Riverside Energy Park

Applicant's response to Thames Water Deadline 4 Submission

8.02.50

August 2019 | Revision 0 (Deadline 5) | APFP Regulation 5(2)(q)

Figure 1.1: Extract of 6.1.1 from the Design and Access Statement

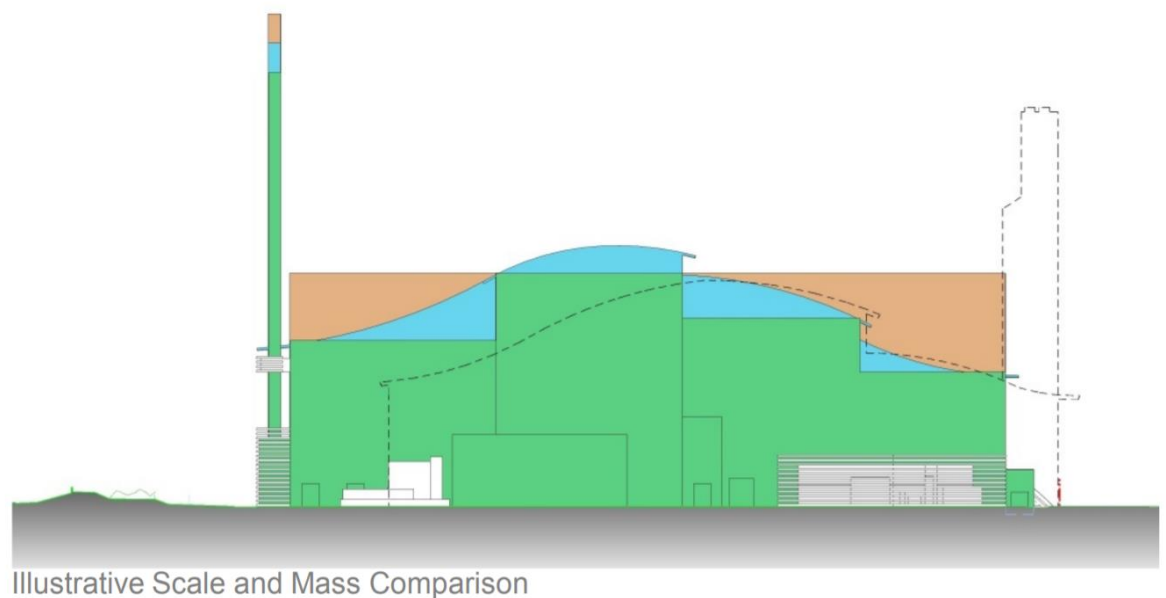
- 1.3.6 TWUL expresses a view that the curved roof design is more aesthetically pleasing, better suited to the local environment and would be less imposing than the stepped roof design on the basis that there are already curved roof buildings which form distinctive landmarks in the immediate vicinity of the Crossness LNR. TWUL also states that the curved roof would, in its opinion, visually soften the impact of the project being larger than those adjacent existing developments.

- 1.3.9 The Applicant has stated previously that the stepped roof minimises the massing of the main building and is the lowest in height. On this basis the Applicant considers that the stepped design is the least imposing and is best suited to the local environment in respect of minimising shading effects and visual intrusion. The Applicant also notes that there are existing flat roof building forms in the vicinity, including on the eastern side of Norman Road

and as seen and set out in **Sections 3.2.1, 3.2.2 and 3.4.1** of the submitted **Design and Access Statement (7.3, APP-104)**. The built form in that local area therefore comprises a mix of flat and curved roofs, including the ribbon of different built forms along the river. In the context of EN-1 set out above, the Applicant does not consider that this context provides any reasonable justification for a site-specific curved roof treatment which would undermine the various benefits of a stepped design set out above, undermine renewable solar energy generation potential and inhibit more accessible maintenance. Use of a curved design would also increase the maximum height of the building with an increased effect on shading. See the comparison of illustrative profiles taken from the **Section 6.1.1** of the **Design and Access Statement (7.3, APP-104)**, where the stepped form is shown green and the curved form in blue.
